#### Regulation No. 46 (Devices for indirect vision)

### Proposal for 04 series of amendments to Regulation No. 46

#### Submitted by the expert from the Netherlands\*

Figure 7:

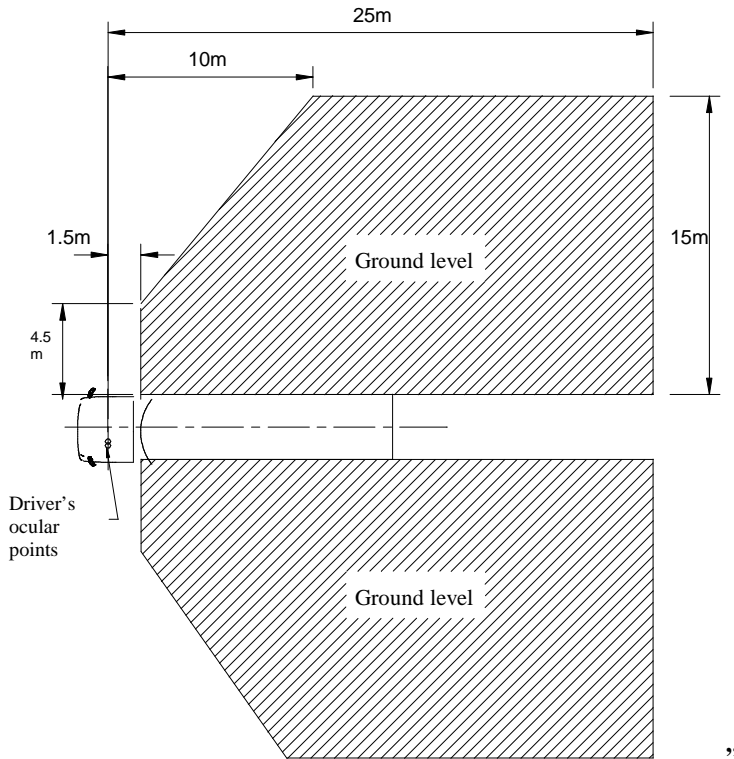
~~Field of vision of Class IV wide-angle mirrors~~ **Class IV wide-angle field of vision**

33. Alignment of the text with the new definition of classes (paragraph. 2.4). Figure 7 has been corrected on the passenger's side so that the indicated dimensions are in correspondence with the front of the grey area.
